CITY OF CODY  
PLANNING, ZONING AND ADJUSTMENT BOARD  
TUESDAY, JUNE 10, 2014  
CITY HALL COUNCIL CHAMBERS @ 12:00 NOON

**CITY OF CODY  
PLANNING, ZONING AND ADJUSTMENT BOARD  
STAFF REPORT**

<b>MEETING DATE:</b>	JUNE 10, 2014	<b>TYPE OF ACTION NEEDED</b>	
<b>AGENDA ITEM:</b>		P&Z BOARD APPROVAL:	X
<b>SUBJECT:</b>	REVISED LANDSCAPE PLAN FOR GOOD 2 GO GAS STATION AND CONVENIENCE STORE (1200 17 <sup>TH</sup> STREET) SPR 2014-08	RECOMMENDATION TO COUNCIL:	
<b>PREPARED BY:</b>	TODD STOWELL, CITY PLANNER	DISCUSSION ONLY:

<b>MEETING DATE:</b>	JUNE 10, 2014	<b>TYPE OF ACTION NEEDED</b>	
<b>AGENDA ITEM:</b>		P&Z BOARD APPROVAL:	X
<b>SUBJECT:</b>	SITE PLAN REVIEW AND NONCONFORMING USE EXPANSION: GARAGE IN INDUSTRIAL ZONE SPR 2014-17	RECOMMENDATION TO COUNCIL:	
<b>PREPARED BY:</b>	TODD STOWELL, CITY PLANNER	DISCUSSION ONLY:

Prior and proposed landscaping plans.

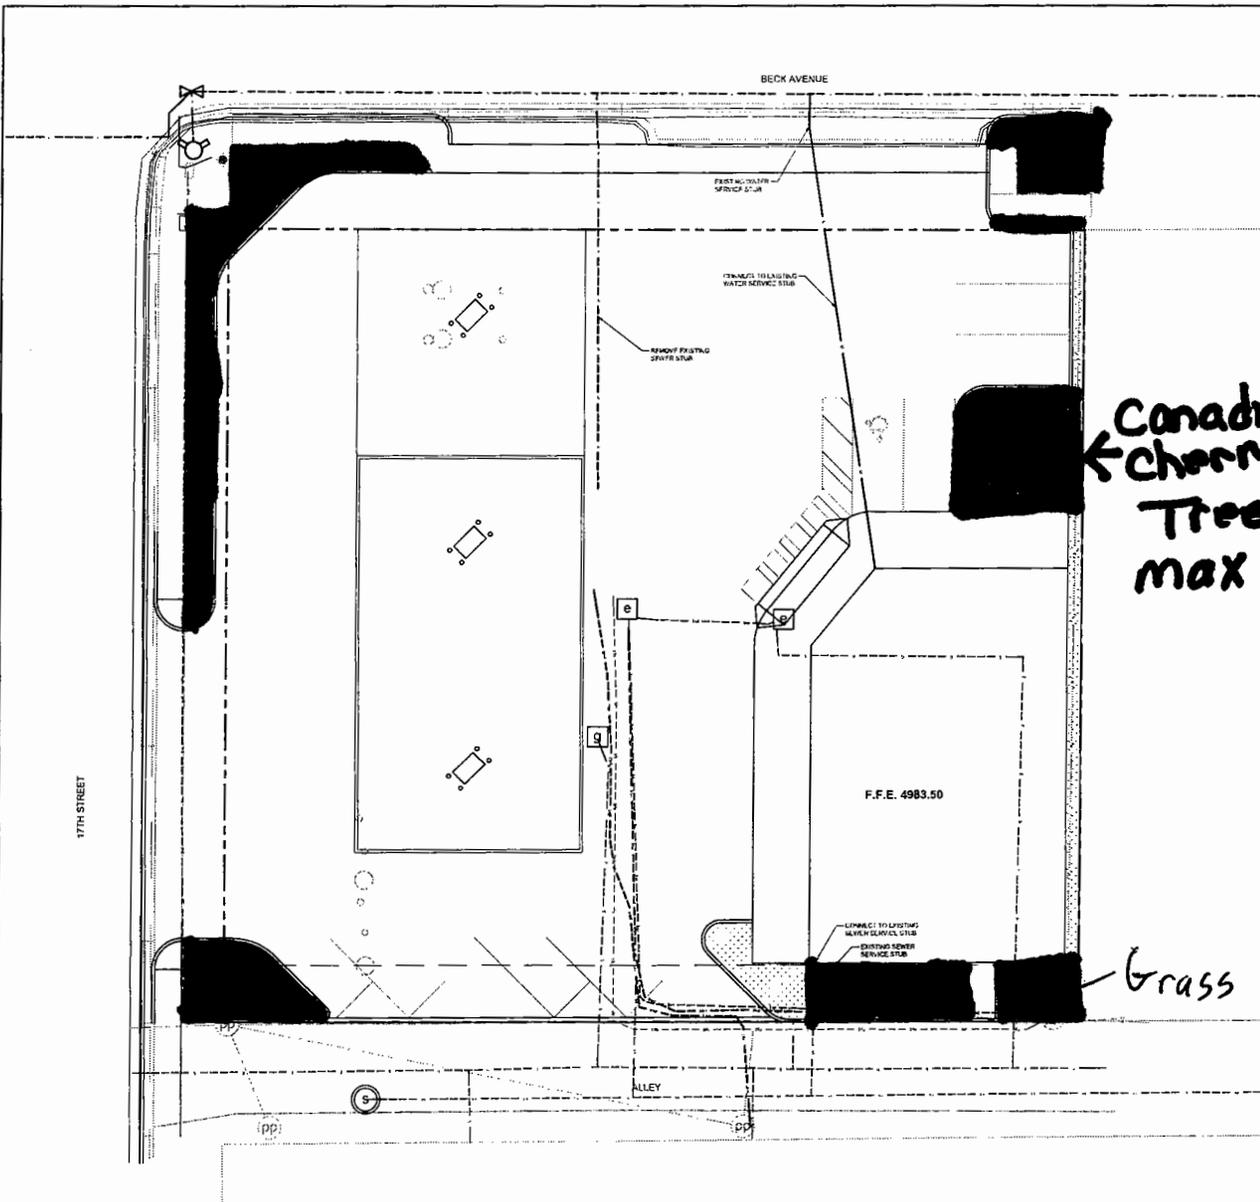
The change to grass will definitely add color, yet it lacks the vertical component provided by the shrubs and trees in the prior plan. WYDOT does not want trees in their right-of-way which rules out trees in the west landscape beds. It appears that there would be the option of also planting a tree in the landscape area at the northeast corner of the property.

The choice of tree variety appears acceptable, based on climate (hardy to approx. -30 degrees) and size at maturity (20-30 feet). The tree does have fragrant flowers in spring and a small fruit attractive to birds. Its leaves turn purple soon after emerging.

**SITE PLAN**  
 SCALE 1" = 20'-0"

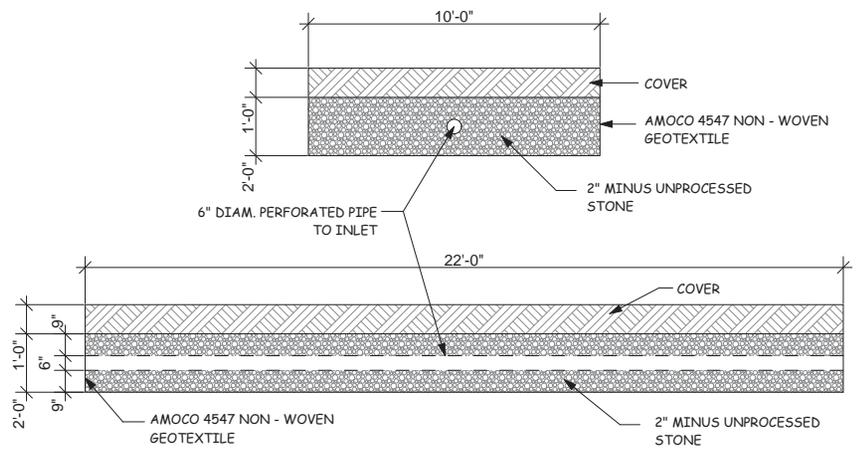
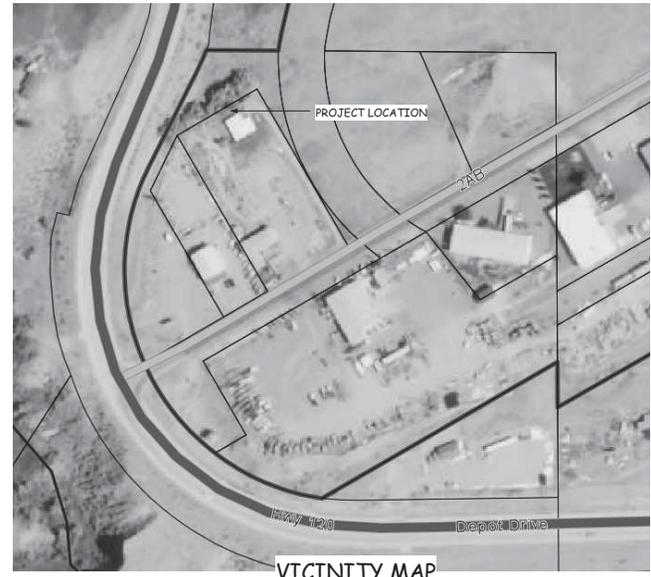
A percolation trench has been designed and is shown on the plans. Technically, so long as the garage is for personal use it is exempt from the city's storm water policy. However, if it is ever used for commercial or industrial purposes, on-site storm water retention would be required. Therefore, the applicant has the option of installing the percolation trench at this time, but it is not required.

Grant zoning approval for the project, as submitted, which approval is for the site plan and expansion of the nonconforming residential use. The percolation trench is optional while the shop is used for personal residential use.

**EAST ELEVATION**

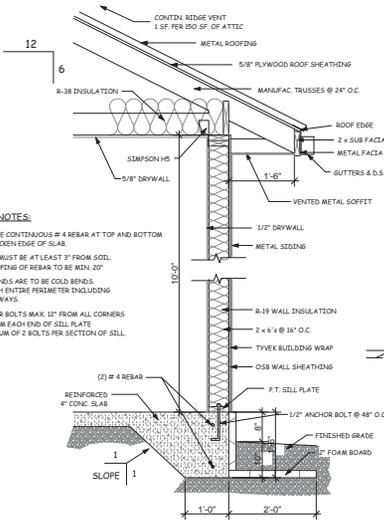
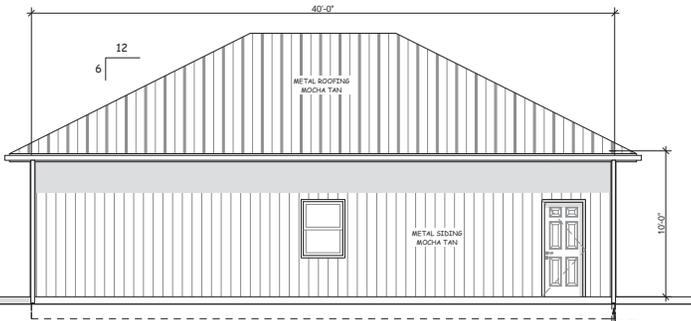
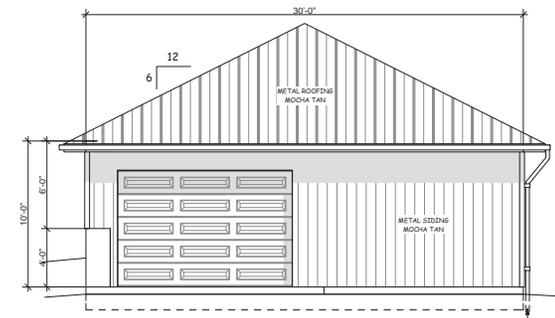
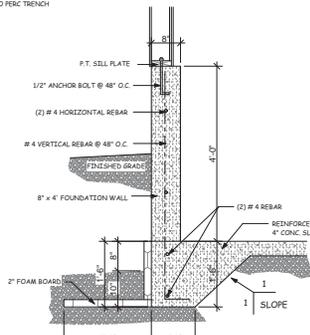
An elevation drawing of the building is included, which shows a 10-foot tall perimeter wall and a 6:12 pitch gable roof. The siding, roofing, and trim will be metal. The siding and roofing will be a "mocha tan" color, and the trim will be white. The building is of typical shop architecture, which is common in the Industrial Zone.

Staff has no concerns relating to architectural compatibility with the proposal.

# PROJECTING SIGN

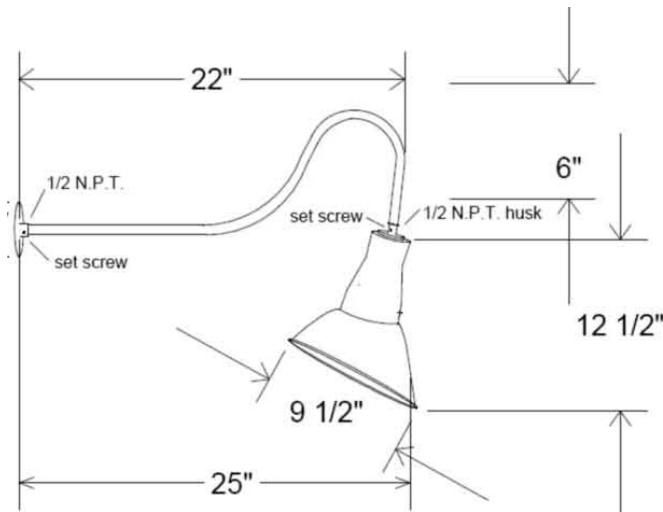
The projecting sign is 22.5 square feet per sign face, where 25 square feet is permitted. Specific requirements for projecting signs are that they project not more than three feet from the building wall (per definition), be not less than eight feet above the sidewalk, and be at least two feet behind the curb line. The sign should be interpreted to meet these requirements, provided the sign is mounted with its side flush against the building.

It is also noted that the projecting sign does project into the City right-of-way, as the front of the building is on the property line. The sign code appears to grant automatic permission to do so on city streets, provided the sidewalk clearance and curb distance requirements are met. Furthermore, there is a section in City Code, outside of the zoning ordinance which states:

Due to existing overhead power lines above the sidewalk, there are also clearance requirements from the power line. The electrical superintendent is interpreting the National Electrical Code (Table 234-1, Horizontal Clearance from Signs) to require a 1.5

meter (4' 11") separation from the power line to the sign. Based on staff's rough measurement, the power line is about 7'3" from the building and the clearance would be provided if the top of the sign is mounted 2'6" below the height of the power line.

External illumination of the projecting sign will be accomplished by gooseneck LED light fixtures on each side of the sign. (For comparison, Walgreens uses a similar type.) The lights will have light sensors and timers to come on at dusk and turn off at close.

Approve the signs, subject to the projecting sign being mounted flush against the building and with its top at least 2' 6" below the height of the power line.

# CHANGING COLOR OF BRICK FACADE

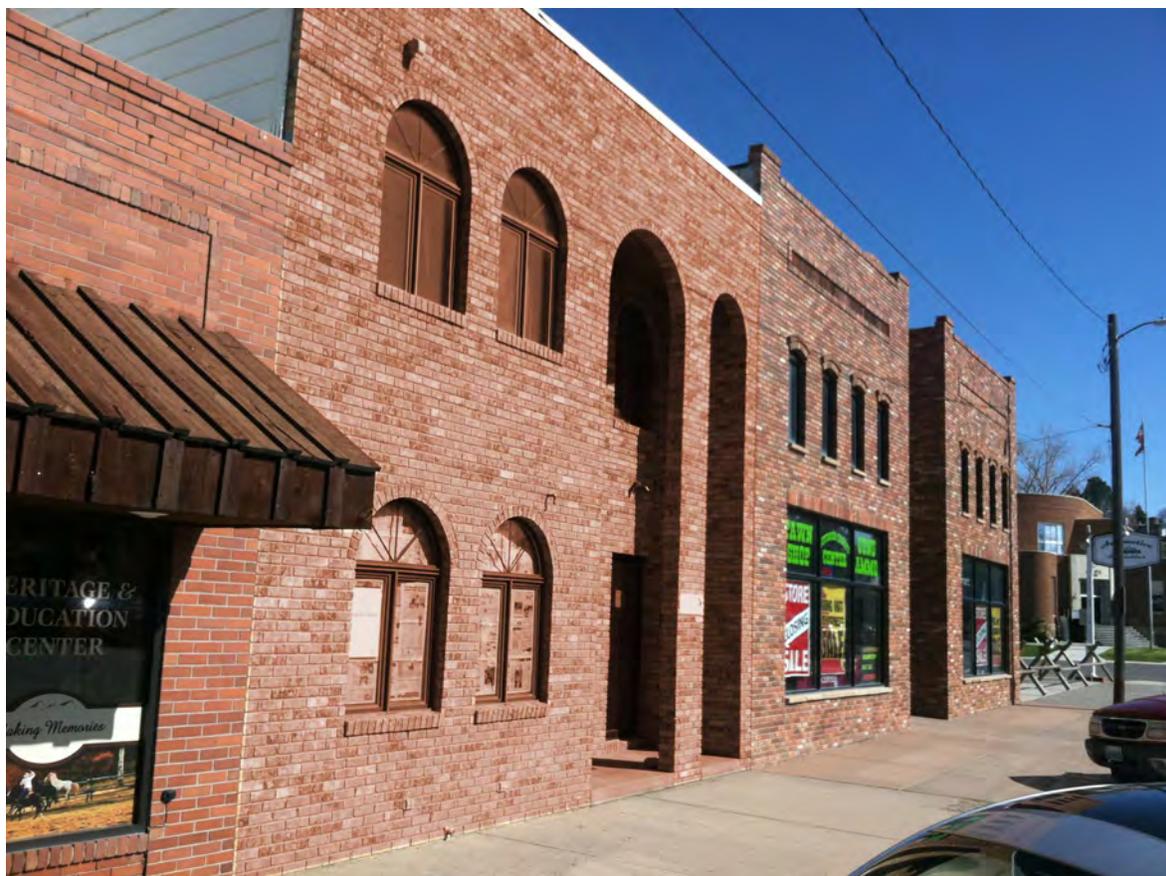
The proposed brick staining to change the yellow/blonde bricks to red/rust is intended to bring the building into the same color scheme as the buildings on both sides. Due to the existing raked mortar joints between the brick (see photo), which exposes a little of the top, bottom, and sides of the brick, the fact that the bricks are stained will likely be visible close up, but from a distance it is expected to blend well. Any restrictions from the Board pertaining to the coloring of the bricks are limited to suggestions.

And authorize the staining of the brick, with or without making recommendations and suggestions.

**ADA RAMP AND CURB OPENING BLOWUP (DOUBLE SCALE)**

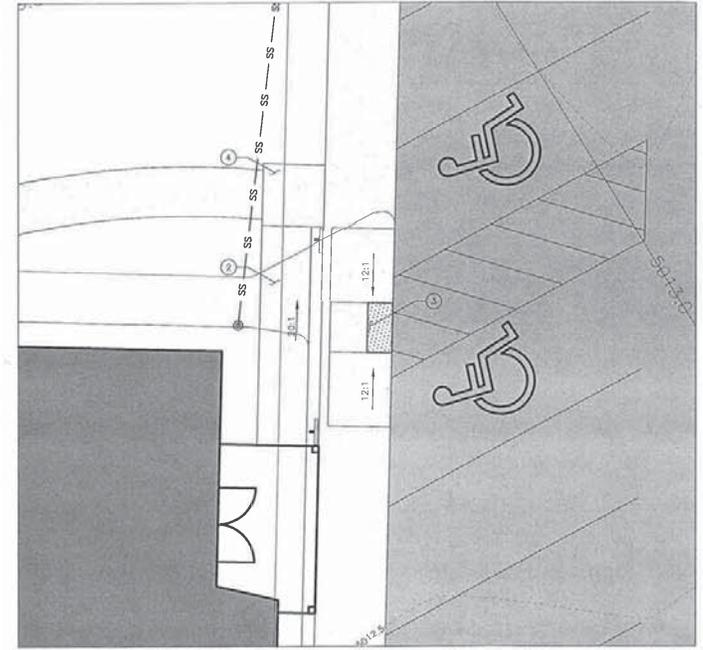
The 4' wide gravel pathway connecting the parking area with the Gee property should be installed prior to occupancy of the office building. The route shown on the attached drawing will need revised, but the concept will work.

**1** BASEMENT PLAN  
728 S2 P

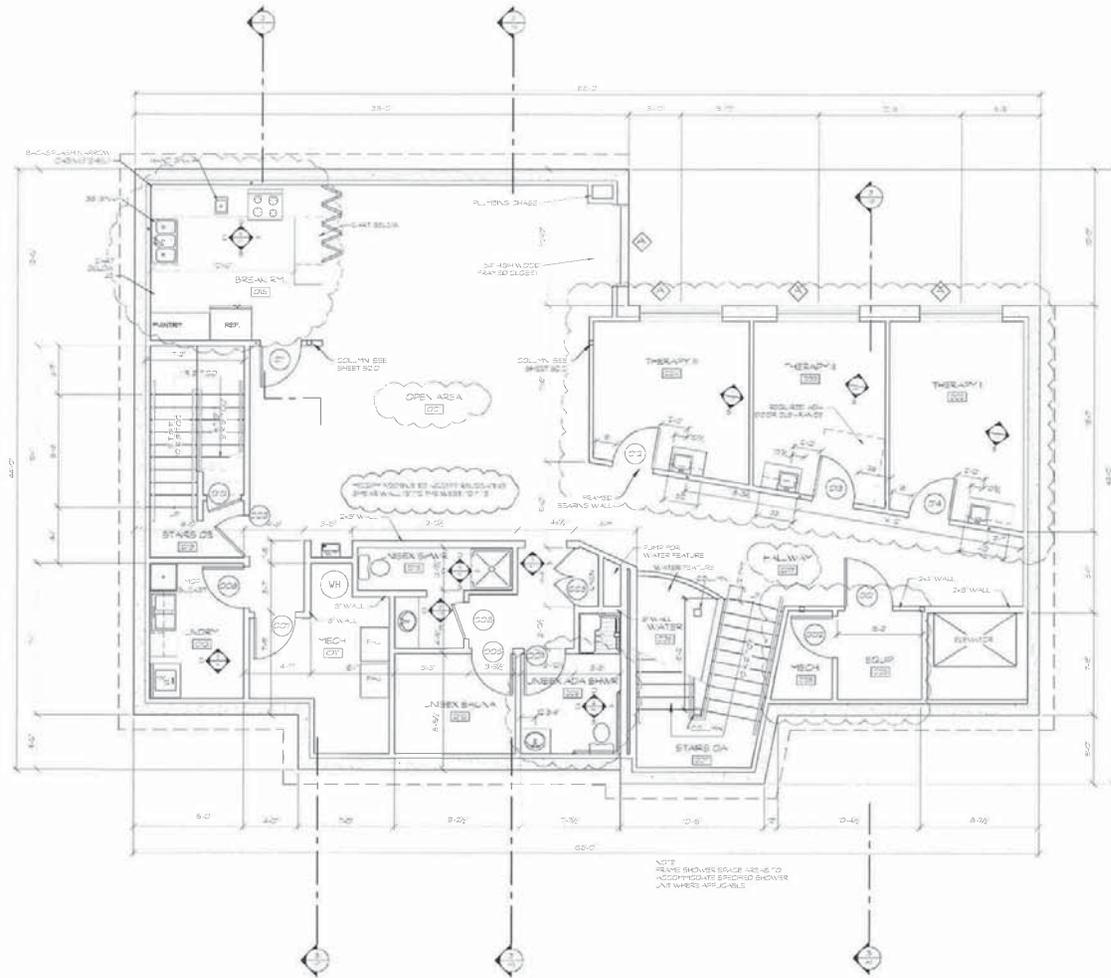
The office building basement has 816 feet that was not allowed to be occupied without providing additional parking. The parking ratio for medical office buildings is 1 space per 200 square feet, which would require four spaces for the 816 square feet. With the additional parking, the area is planned to be developed with a break room and three therapy rooms. The proposed plan is attached.
